MIL-PRF-6106/19F
AMENDMENT 1
5 March 2001

RELAYS, ELECTROMAGNETIC, PERMANENT MAGNET DRIVE,
25 AMPERES, SPDT, HERMETICALLY SEALED

This amendment forms a part of MIL-PRF-6106/19F, dated 10 November 2000, and is approved for use by all Departments and Agencies of the Department of Defense.

FIGURE 1. Relay, outline drawing.

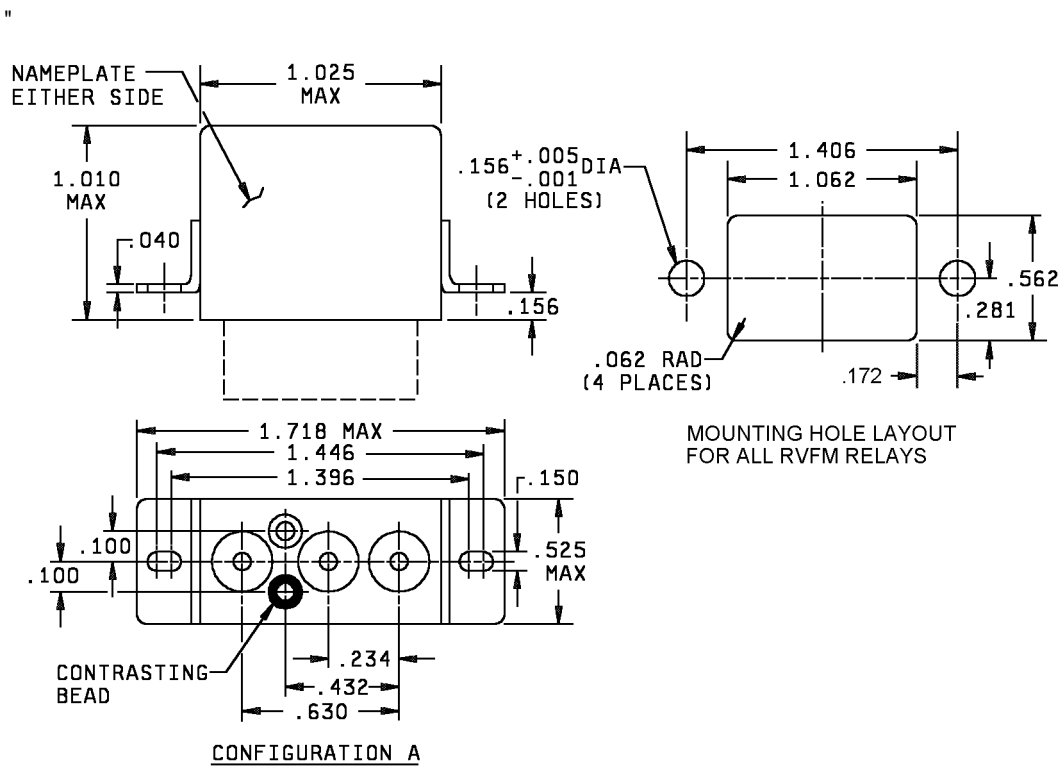
FIGURE 1: delete and substitute the following to correctly show the .172 dimension for the mounting hole layout and to change the description from "solder pin relays" to "RVFM relays".
